ES18.6

**BLAENAU GWENT COUNTY BOROUGH COUNCIL LOCAL
DEVELOPMENT PLAN EXAMINATION**

SESSION 18: MINERALS SITE ALLOCATIONS

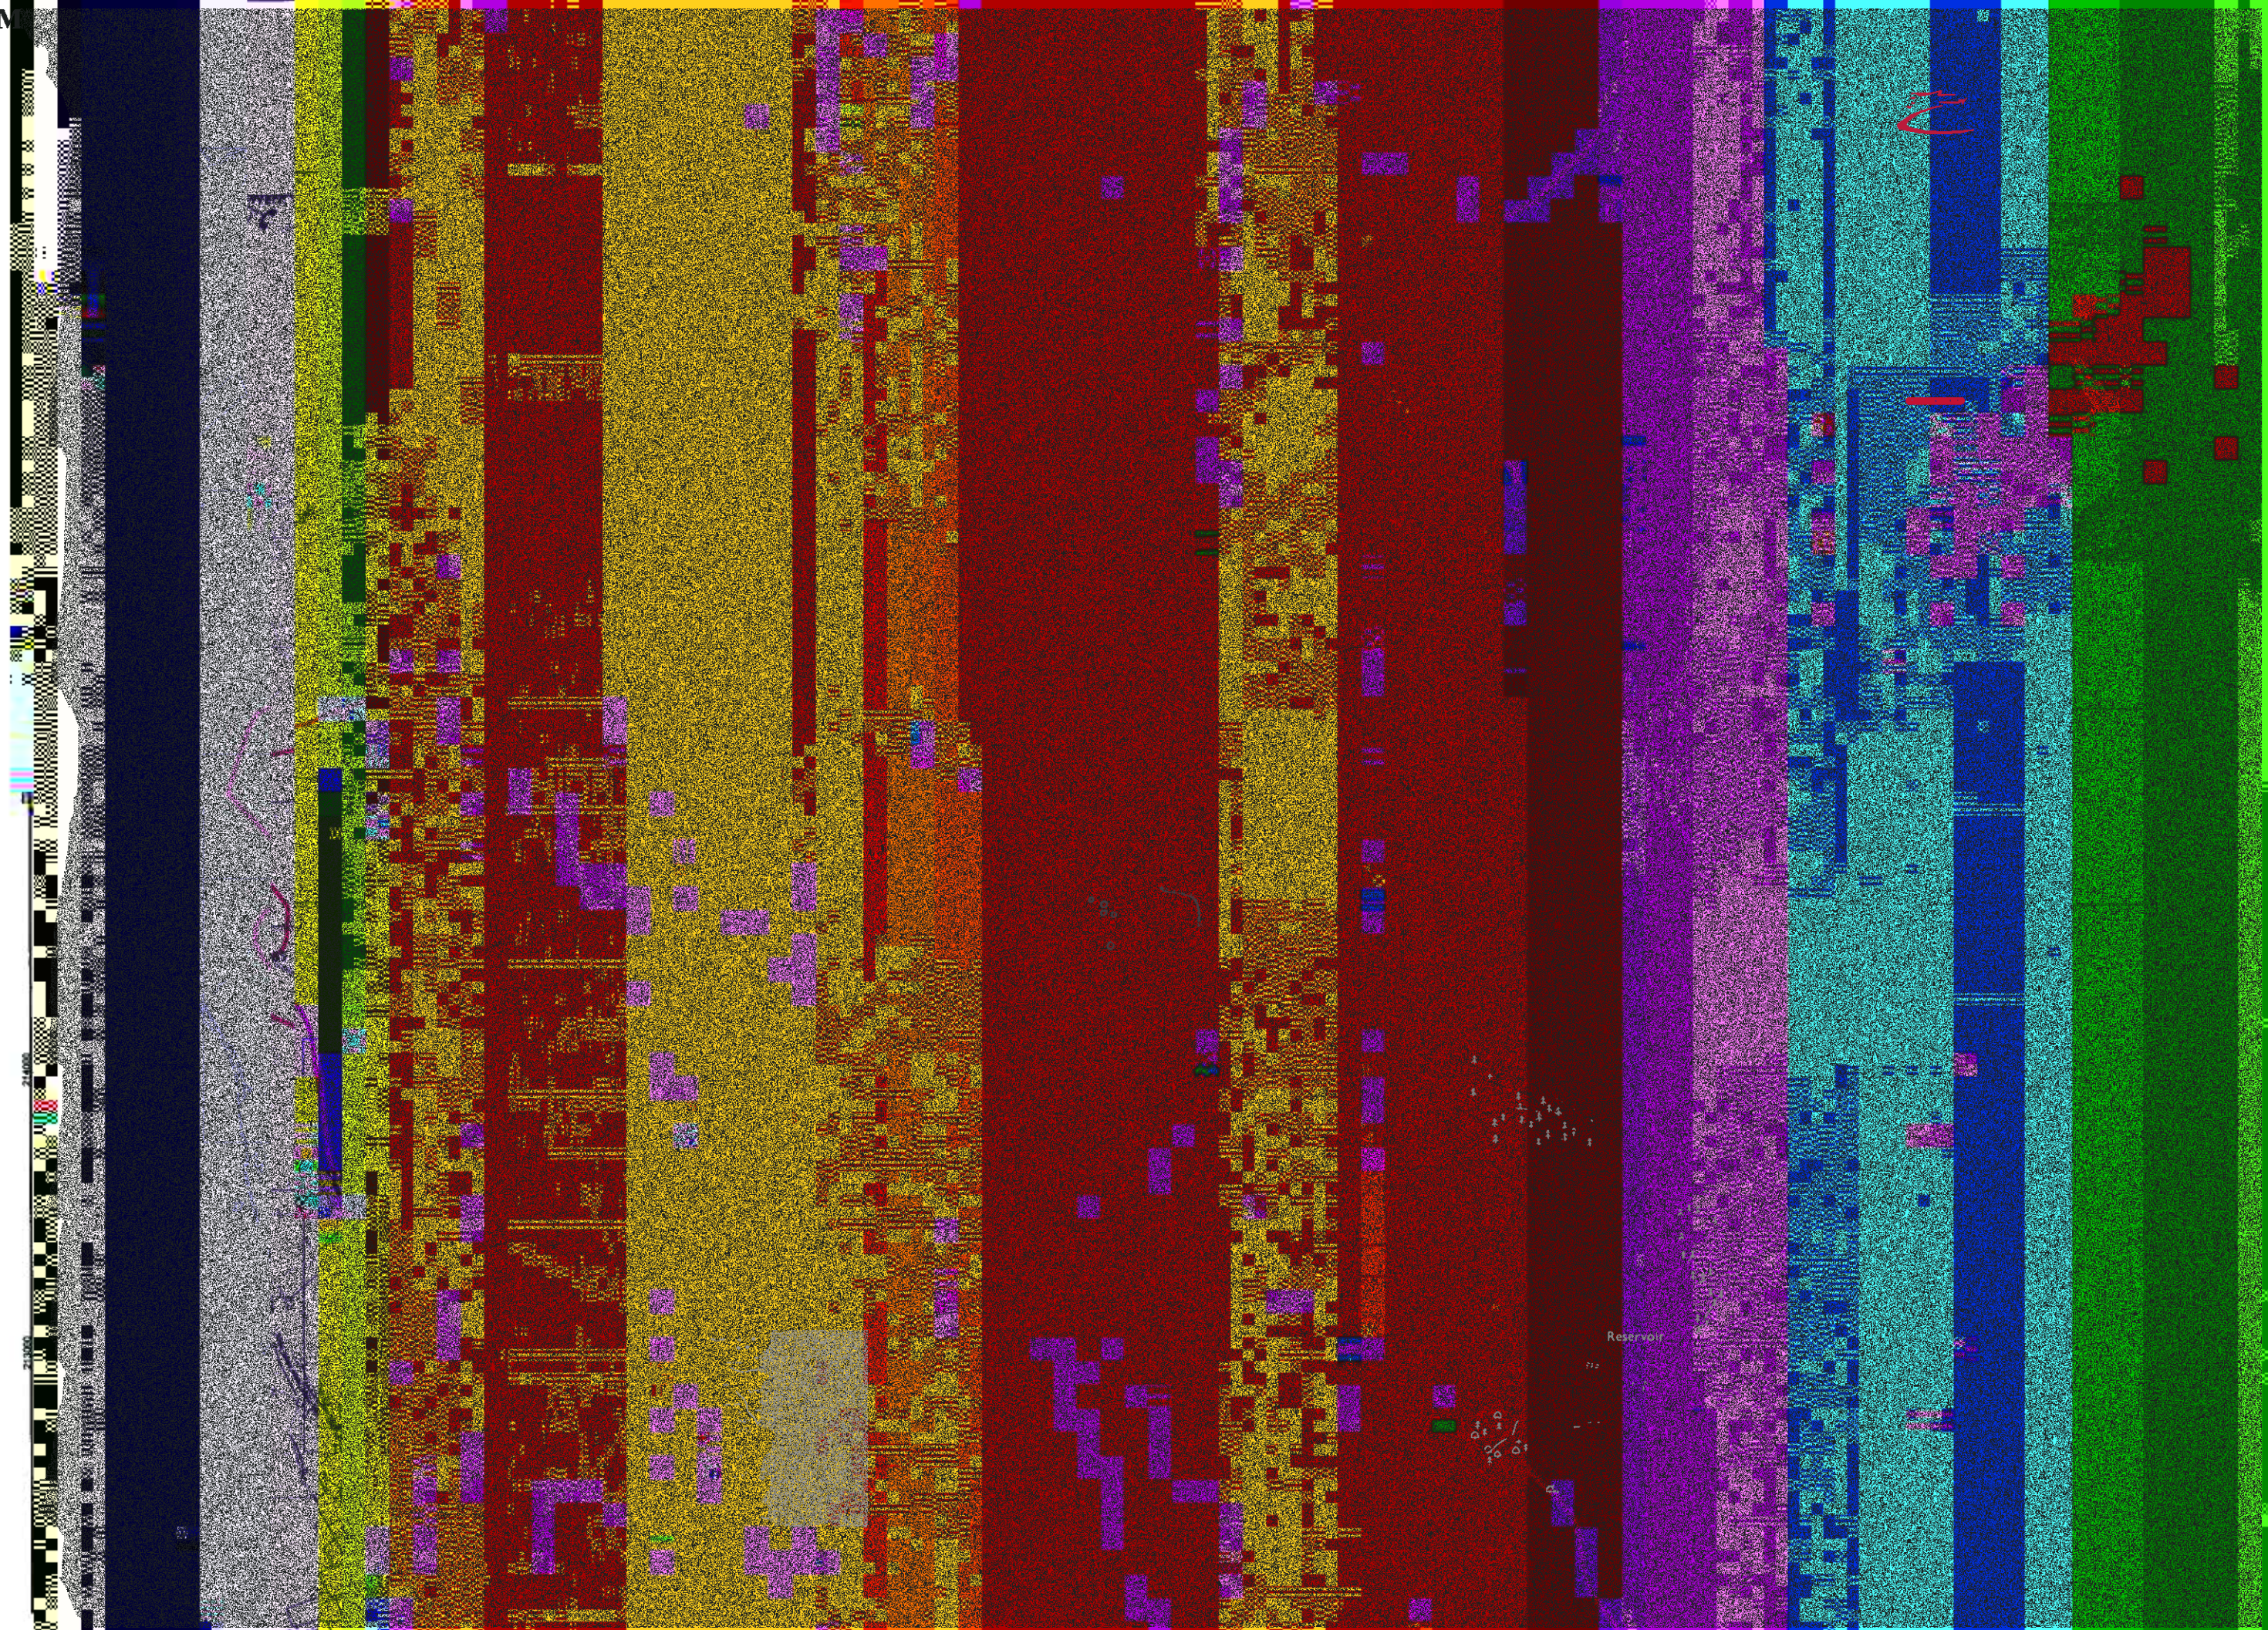
The dolines (both caprock and normal 'solution' dolines) in the allocated site were not fully reflected in the indicative Geological Conservation Review (GCR) boundary that was originally drafted, and following further survey it is now proposed to correct those imbalances by proposing a new GCR/pSSSI boundary that contains all of the interstratal karst interest features that have been identified by the assessment of Mynydd Llangynidr. The indicative boundary drawn in 1982 also included areas with no dolines. These have now been removed from the revised GCR/pSSSI boundary.

The pSSSI includes the land adjacent to Trefil Quarry identified as a preferred area for aggregate extraction in the LDP, Policy M4.1. S

acknowledged importance, contrary to national planning policy, it is not considered that the allocation is soundly based.
